RC2: ['Comment on acp-2021-1061'](#),

Review of “Local to regional methane emissions from the Upper Silesia Coal Basin (USCB) quantified using UAV-based atmospheric Measurements”

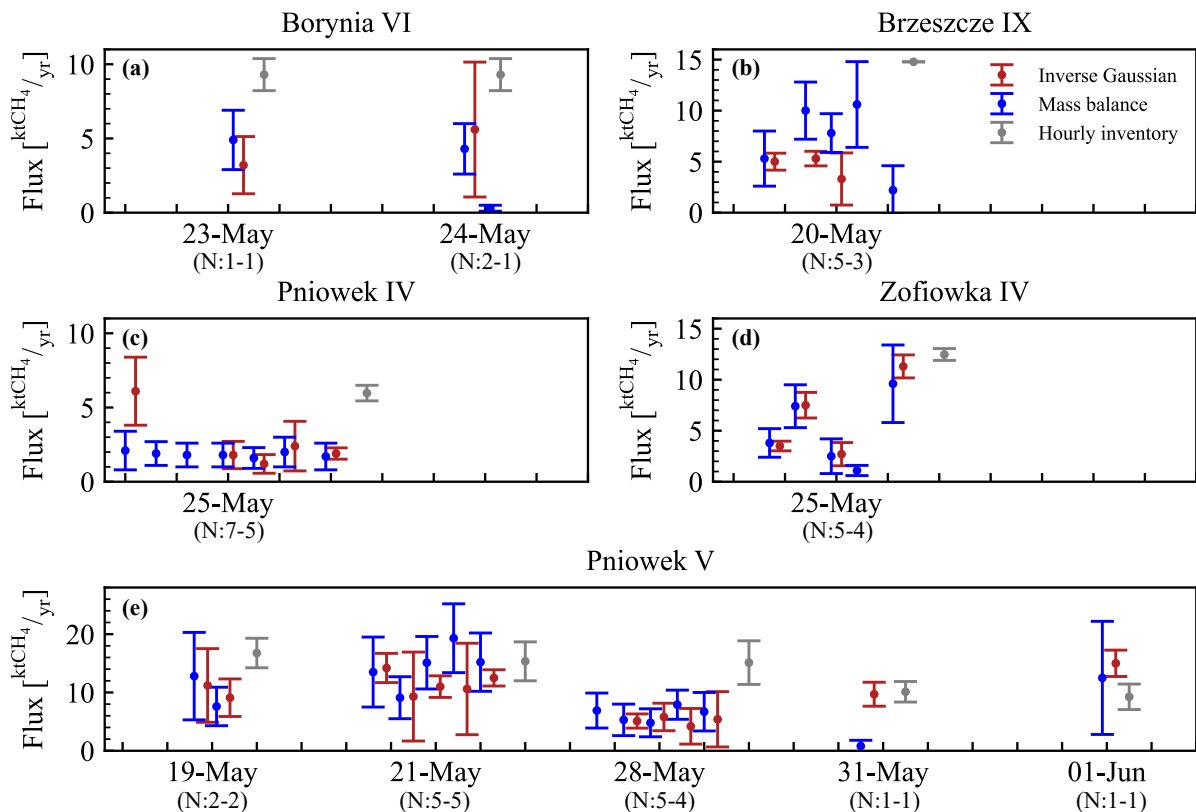
Figure 7: Looking at Pniowek V, for example because it has the longest timeseries, the inventory would lead me to expect higher measured values on the 19th, 21st, and 28th compared to the 31st and June 1st, but that's not exactly what was seen in Figure 6, which shows low values recorded on all of the flights of the 28th and potentially high values on June 1st. Do we have an explanation for this discrepancy? (I actually think it might have been nice to combine Figures 6 and 7, so that we see the overlay of the measurements against the reported inventory directly.)

AR: Thank you, we have updated Figure 6 as suggested by the reviewer, see below. From the updated figure, we can see that the inventory estimates and the UAV quantified emission rates are broadly consistent within large uncertainties.

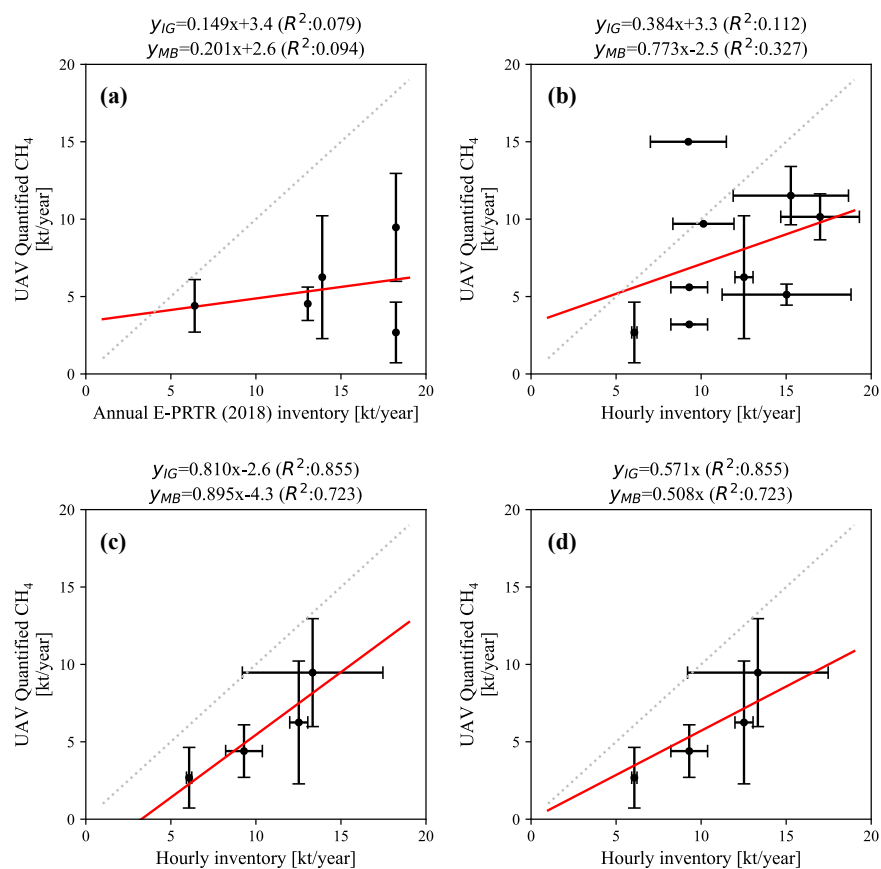
Figure 8: It's difficult to intuit where the 1:1 line would be with rectangular figures like this. Would it be possible to make these figures square with identical limits on the axes,

to really visualize the comparison? Maybe with a dashed 1:1 line, for reference? (I understand that this might necessitate dividing this up into 2 figures, in order to fit on the page.)

Figure 8: It also may be helpful to change the legends of each subplot to indicate that it's the best-fit line from the inverse Gaussian approach, specifically, as is noted in the caption

AR: Thank you for the helpful suggestion, we have indeed updated Figure 8, and added a dashed 1:1 line for comparison. See the figure below.
